PREVOST

WARRANTY BULLETIN

WB12-18

DATE : AUGUST 2012	SECTION : 23 - Accessories
EXPIRATION: AUGUST 2014	
SUBJECT : AFSS HARNESS MODIFICATION IN FRONT SERVICE COMPARTMENT

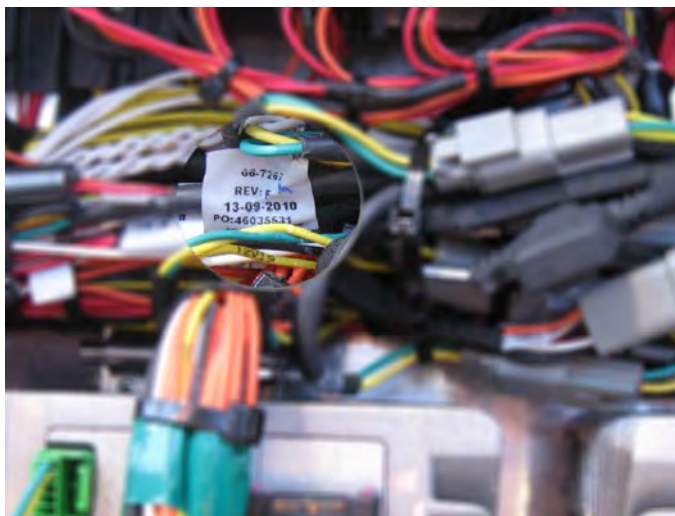
Following the harness path from fuse F45 towards the front of the vehicle, locate the harness identification tab.

This bulletin applies only to:

Harness 067267 RevG

Harness 068270 RevC

Any other version of the harness is not submitted to this modification.

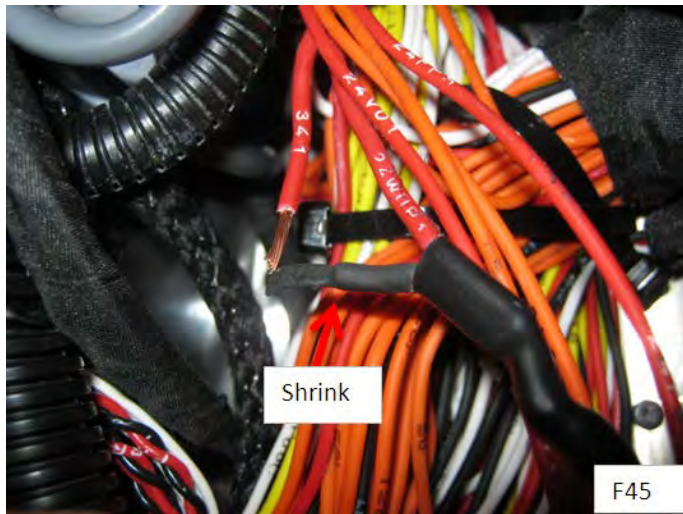
6. Remove electric tape up to splice in harness (Green arrow on photo).

7. Cut wire 341 and slip shrink tube over strand going to F45.

8. Splice a new white wire on the remaining end of wire 341.

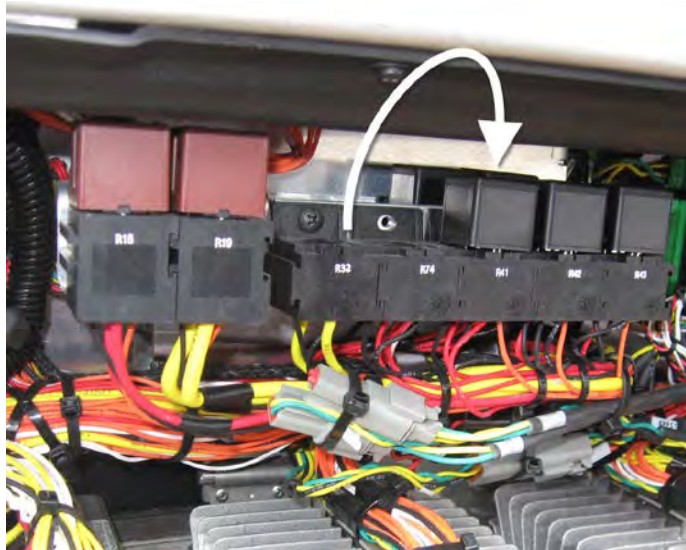
9. Locate R4 relay.

Look behind bracket holding the group of small relays.

10. Route new white wire up to wire 341 on relay R4, pin 86 (Arrow).

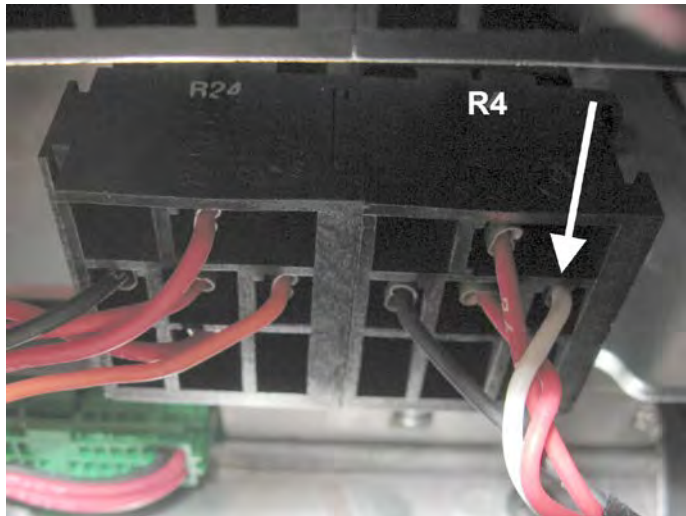
11. Remove wire 341 from relay base.

12. Cut the tab terminal. Strip the wire.

13. Install #561108 new tab terminal and crimp both 341 wires together.

14. Reconnect to pin 86 of R4 relay.
